The result of manual review of FlexPLI

The waveform of the certification examination of Fig. 16

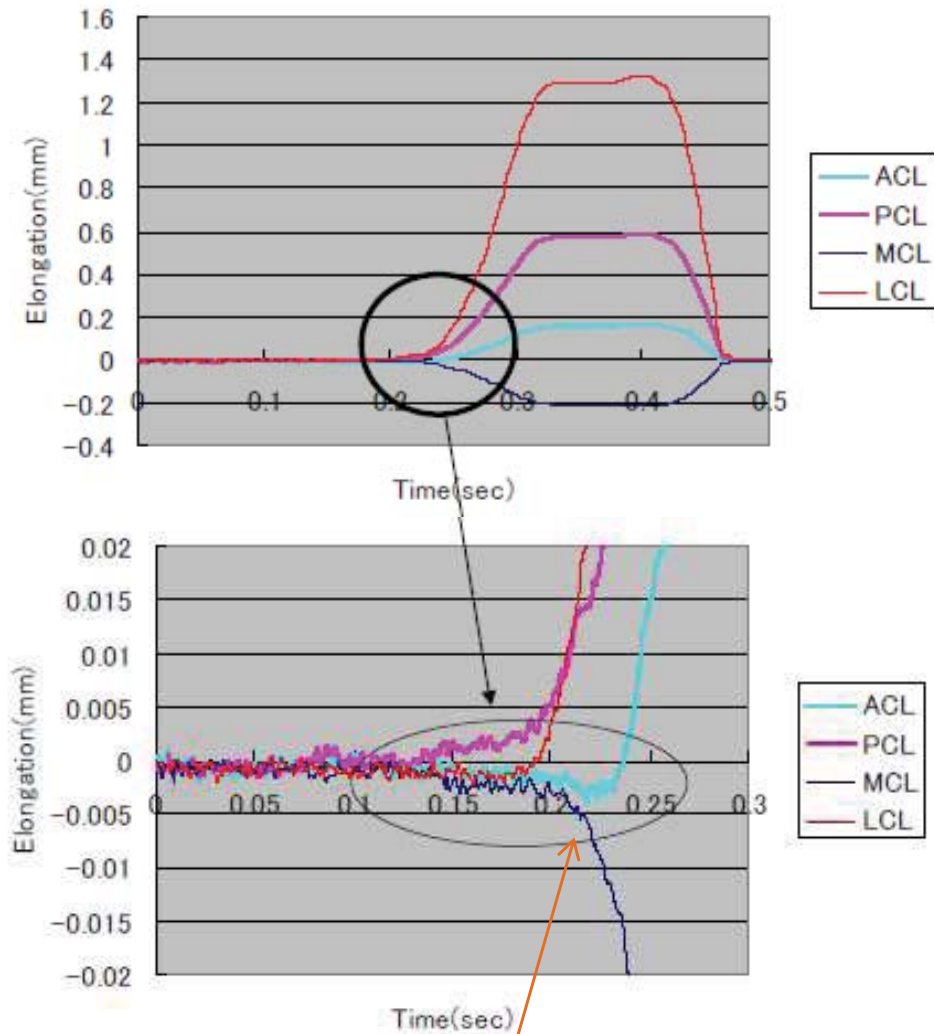
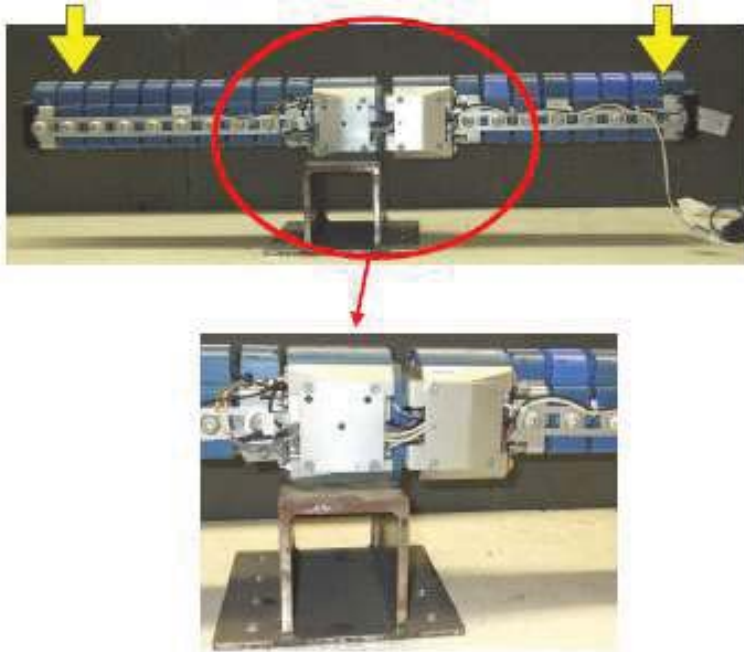
8	2.3.2 Signal Polarity, Sensor function check	25	<p>In the examination of Fig. 16, the output of ACL and PCL is minus in the state of the place where a bend angle in the knees is small. Therefore, you should make a judgment of the output signal of ACL and PCL in the state where a bend angle in the knees is to some extent large. Therefore, for performing the output judging of ACL and PCL, it is necessary to enlarge a knee bend angle to some extent.</p> <p>Refer to the separate attachment diagram.</p>
9	Figure 85	81	The unit of the horizontal axis of the graph of Fig. 85 is not mm but N.

ACL is minus in the stage where a bend angle is small.

The waveform of the knee assembly 3 point bending certification test

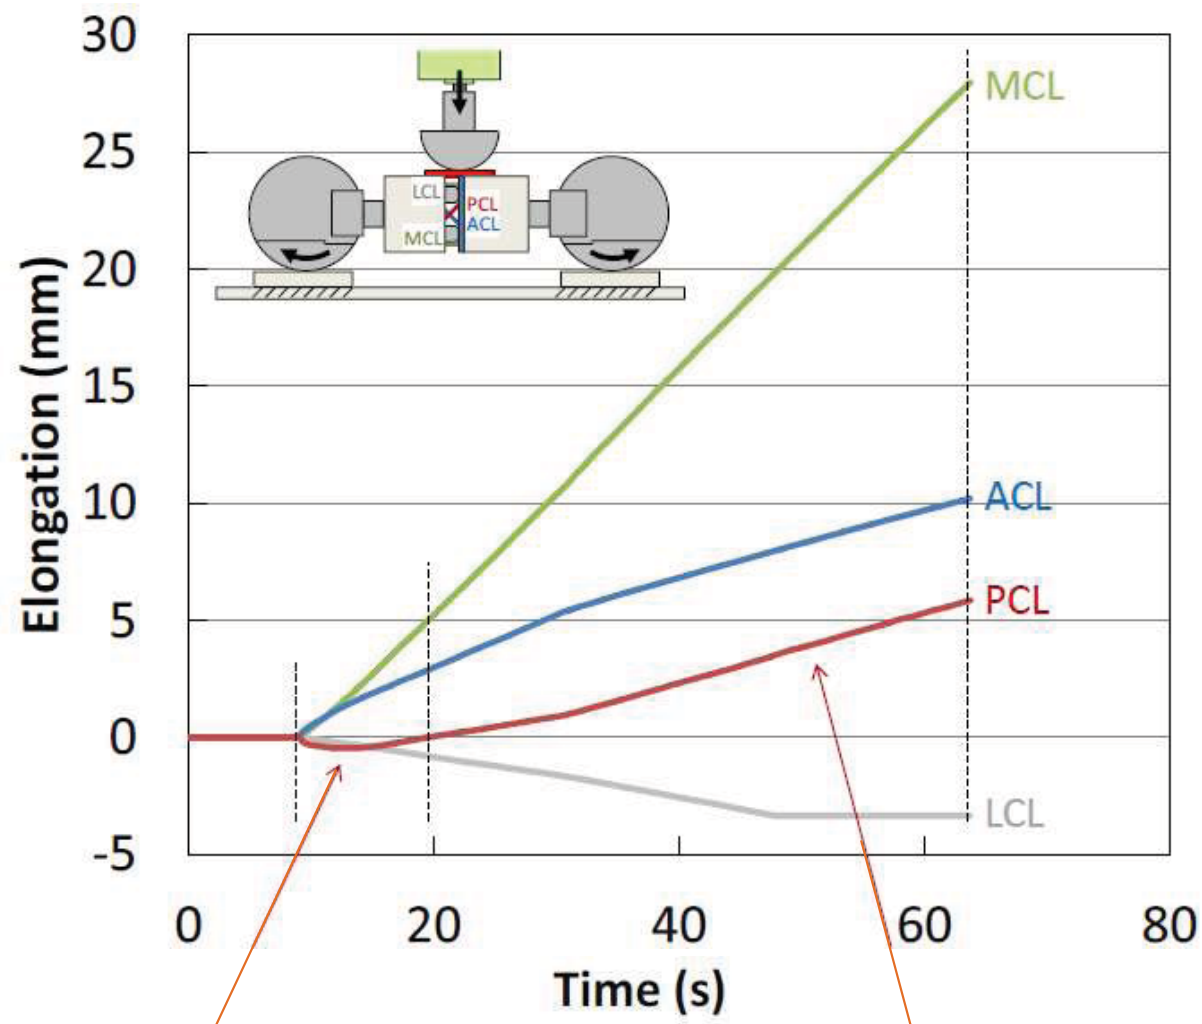
In the range with a small bend angle, PCL is minus.

In the range with a large bend angle, PCL is plus.
